Project	IEEE 802.16 Broadband Wireless Access Working Group < http://ieee802.org/16 >	
Title	Figure Change	
Date Submitted	2007-01-11	
Source(s)	Peretz Feder – Alcatel-Lucent Philip Barber - Huawei	pfeder@alcatel-lucent.com , pbarber@huawei.com
Re:		
Abstract	Changes to Figure 512	
Purpose	Adoption	
Notice	This document has been prepared to assist IEEE 802.16. It is offered as a basis for discussion and is not binding on the contributing individual(s) or organization(s). The material in this document is subject to change in form and content after further study. The contributor(s) reserve(s) the right to add, amend or withdraw material contained herein.	
Release	The contributor grants a free, irrevocable license to the IEEE to incorporate material contained in this contribution, and any modifications thereof, in the creation of an IEEE Standards publication; to copyright in the IEEE's name any IEEE Standards publication even though it may include portions of this contribution; and at the IEEE's sole discretion to permit others to reproduce in whole or in part the resulting IEEE Standards publication. The contributor also acknowledges and accepts that this contribution may be made pu

Figure 512 – C-MBS-IND (Layout) primitive flow

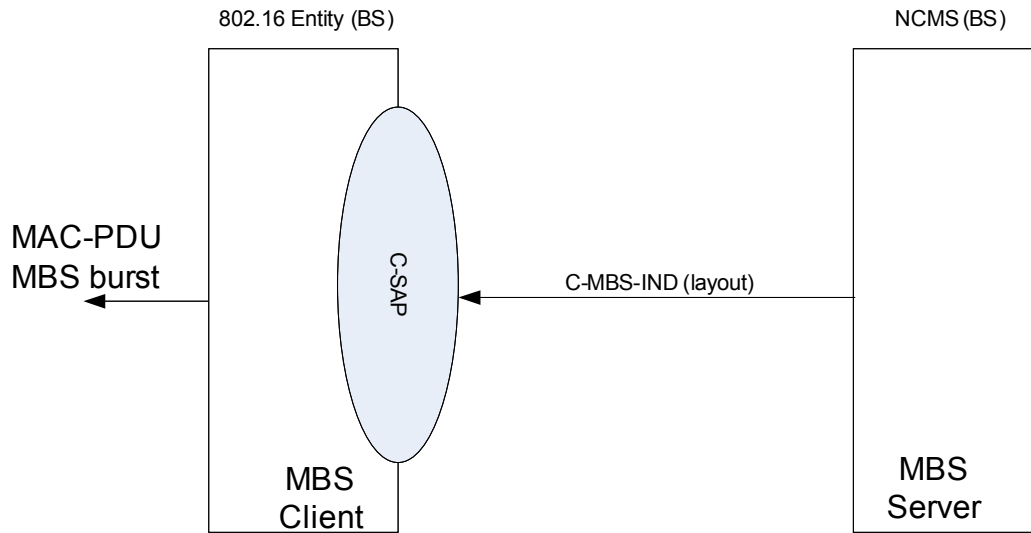
Figure 512 needs to show the affect of the MBS Configuration Management layout change.
